STAFF REPORT
(One-Step Final Plat)

CASE NUMBER: SUB 2011-00018 – REPLAT OF HOLLAND COMMERCIAL ADDITION

LOCATION: Northwest corner of Kellogg and Tyler (District V)

VICINITY MAP

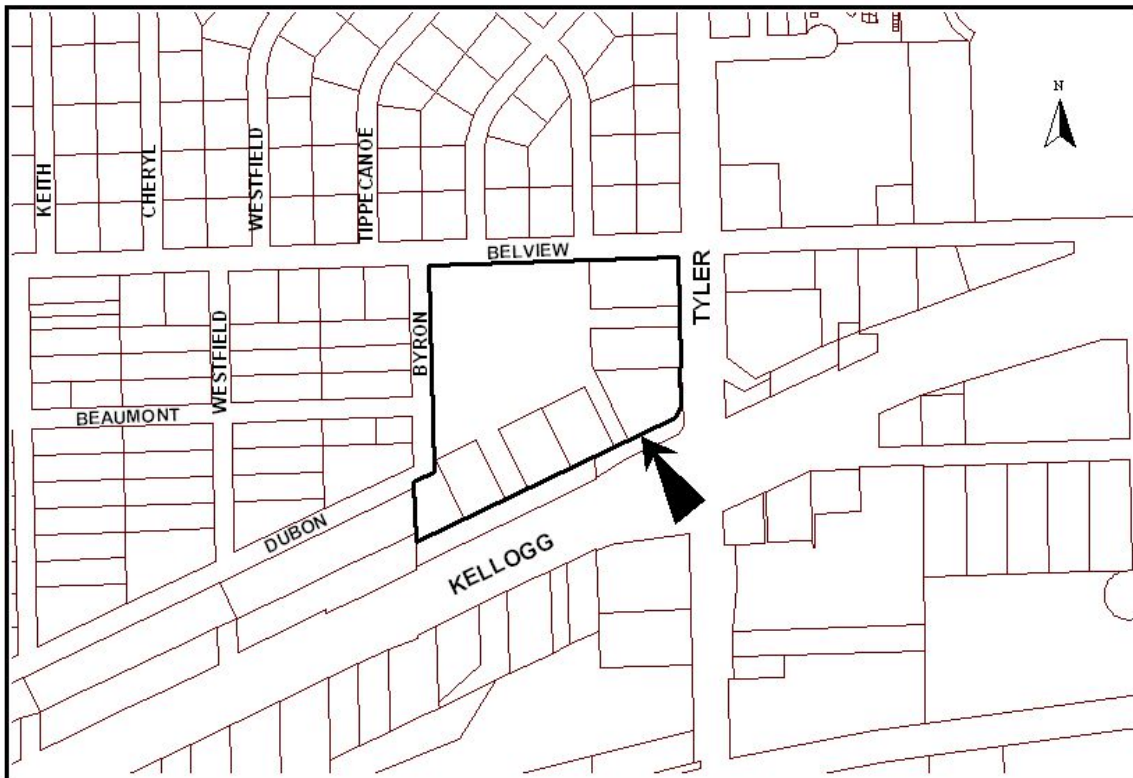
- G. County Surveying advises that the benchmark is 5 miles from plat.
- H. The vicinity map needs to be corrected as Byron is shown on west side.
- I. The mortgagor certificate needs revised to reference "Replat of Holland Commercial Addition".
